CITY PLAN COMMISSION STAFF REPORT

Barryview

CD-CPC-2024-00060
Rezoning without Plan

CD-CPC-2024-00061
Residential Development Plan

Tree Preservation Plan for:
 BARRYVIEW
 Kansas City, Platte County, Missouri

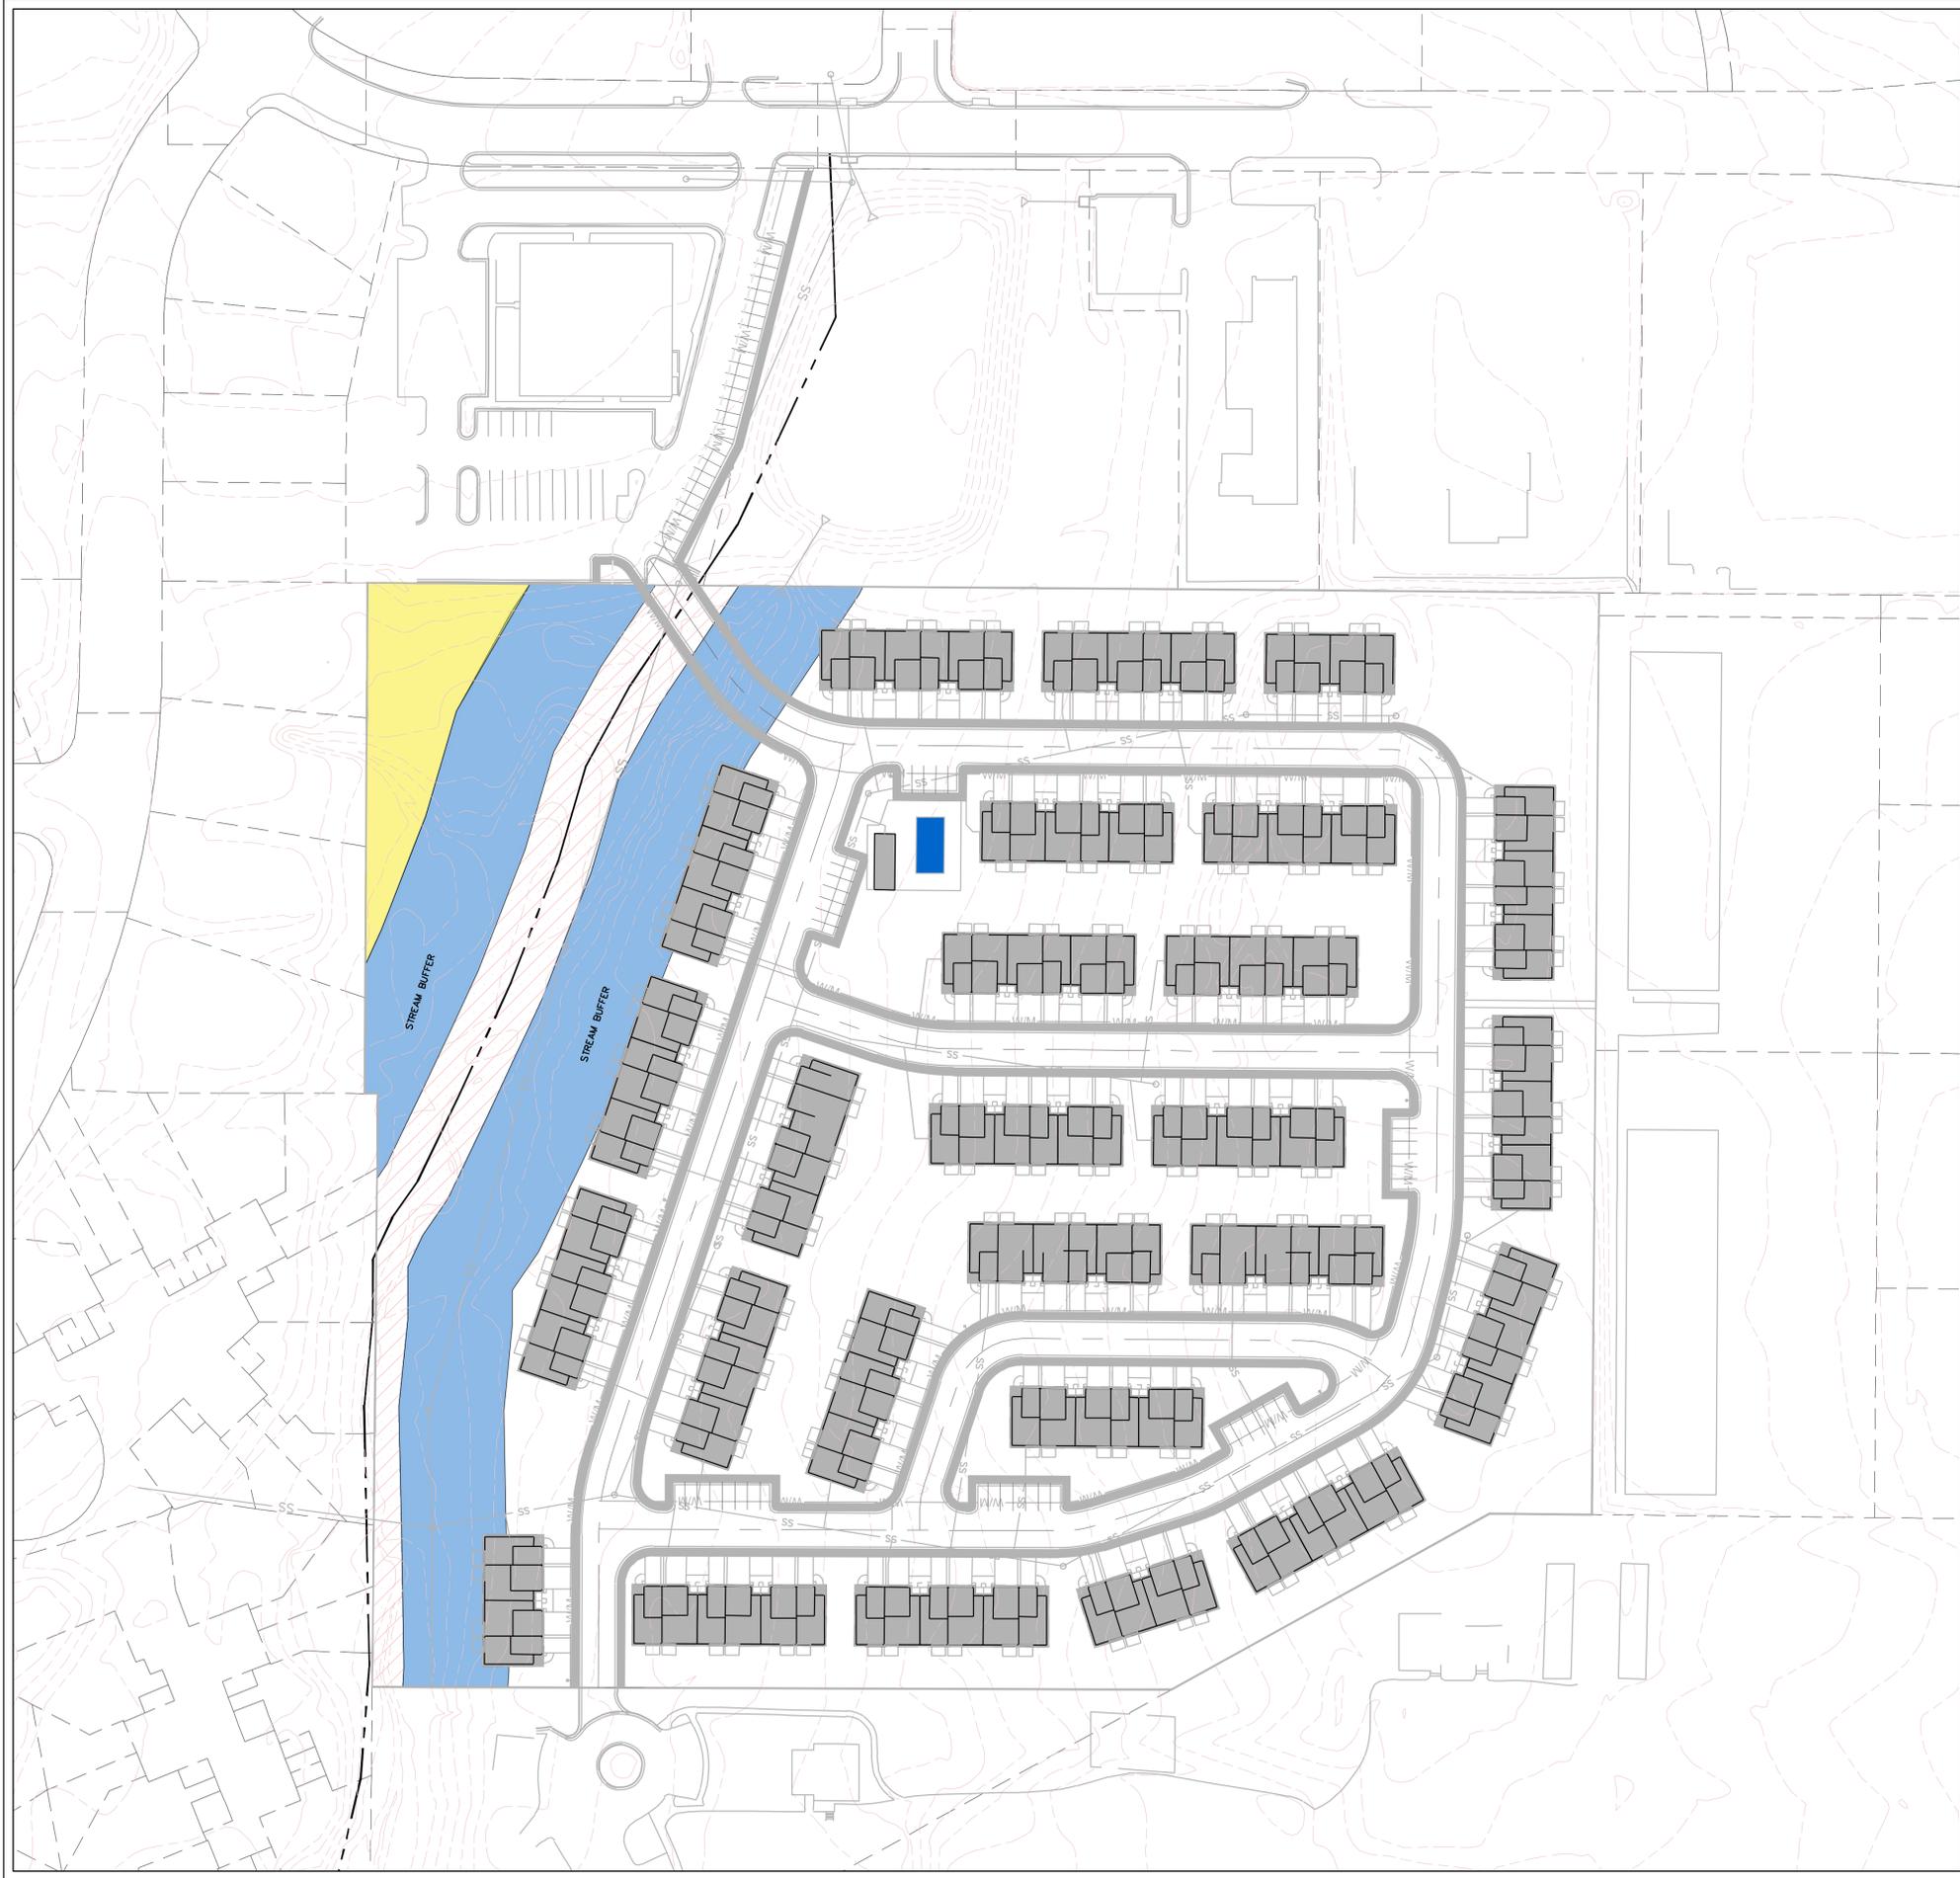
- Sheets L.100 and 101 show 3" calipers. Revise to 2" calipers as these are the maximum recommended by staff.
 - Show and label the location and size of existing and proposed public and private water mains and fire hydrants on the utility plan sheet. Show and label the master water meters and backflow preventers.

- Provide a sidewalk connection along access road all the way to NW 83rd St. I believe the sidewalk ends at the other lot being purchased for access.
 - Provide revised tree preservation plan with 2" caliper trees or total amount of payment in lieu.

Barryview – 4-Plex and 6-Plex

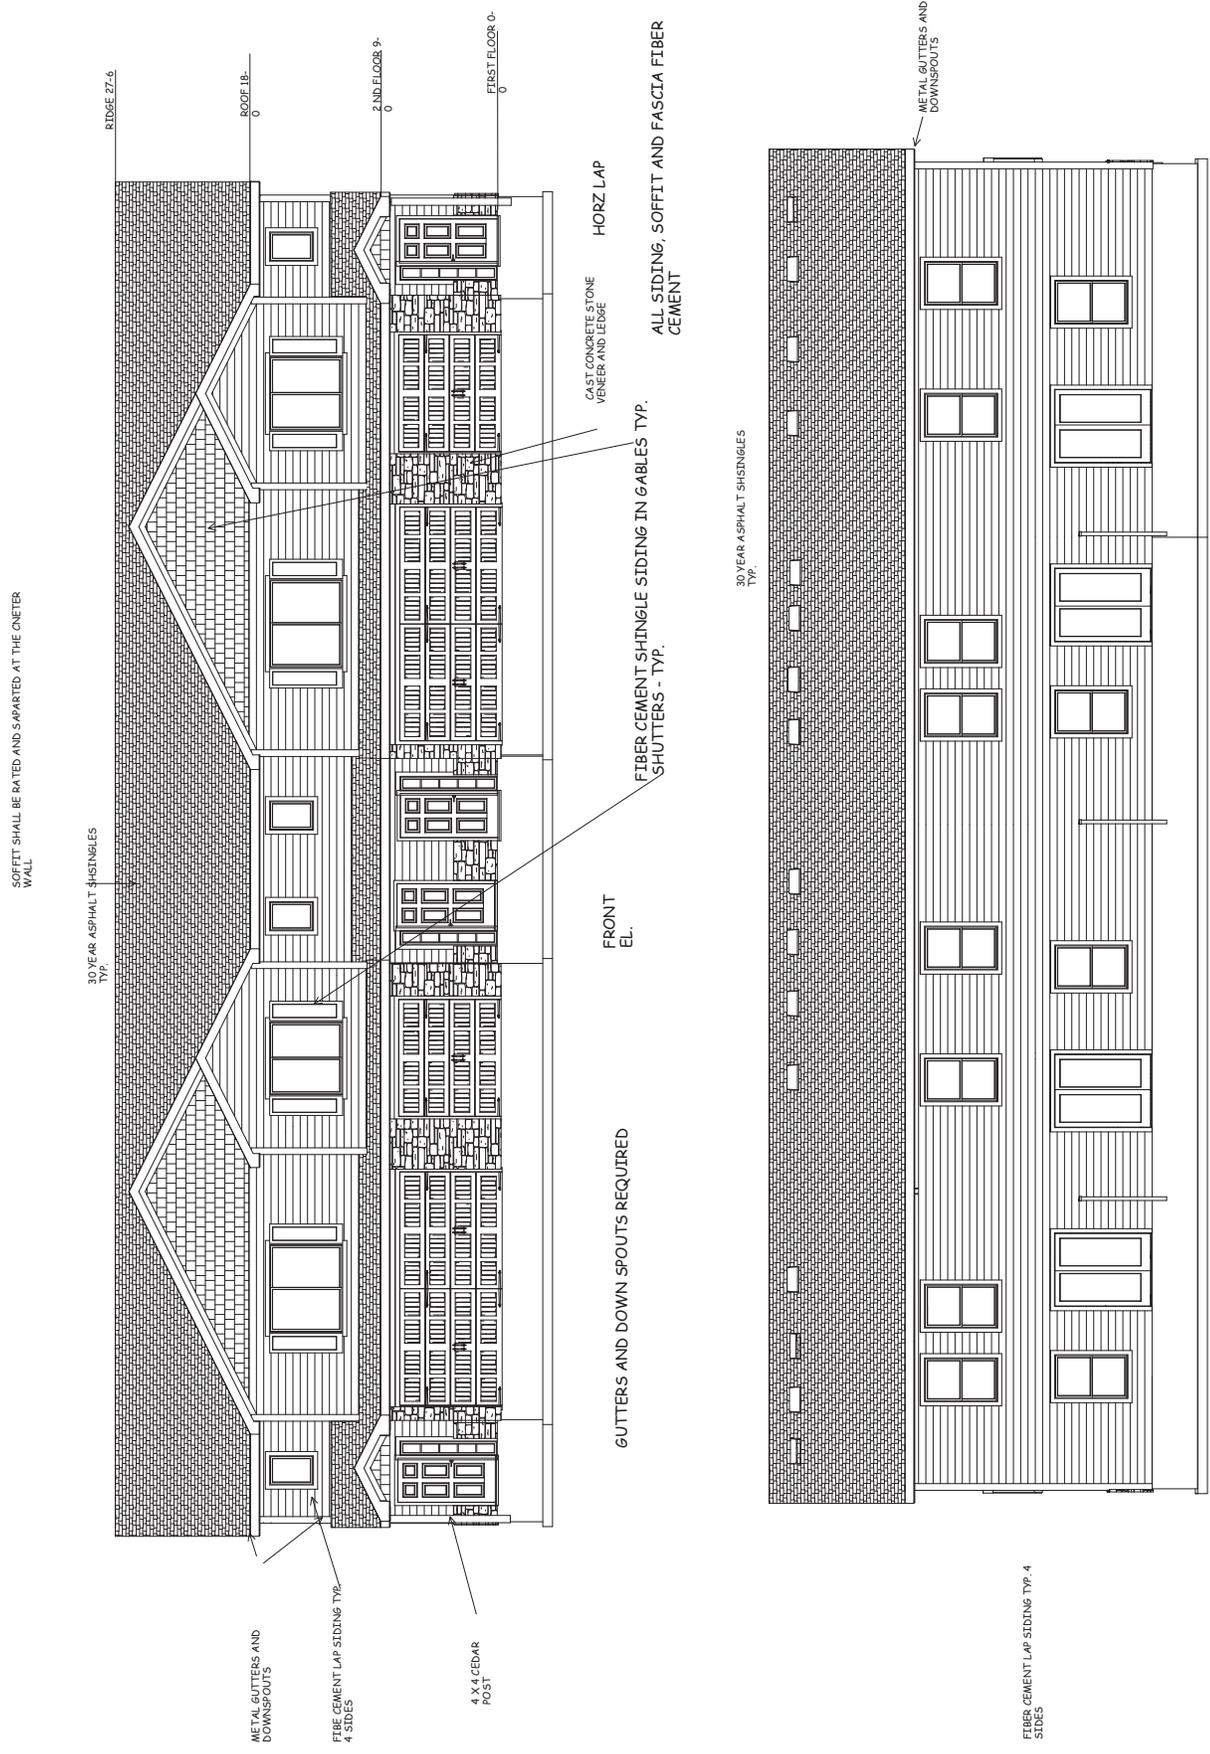
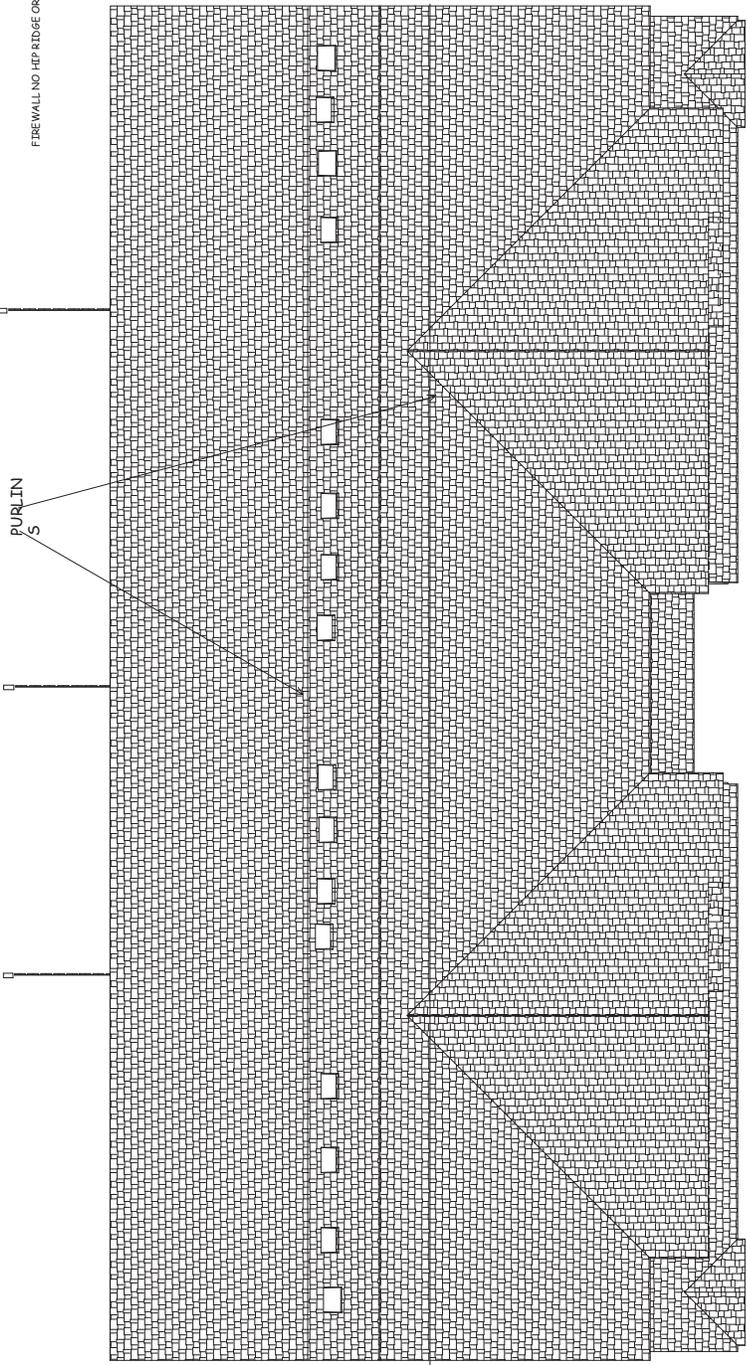
The proposed materials complement the surrounding residential properties.
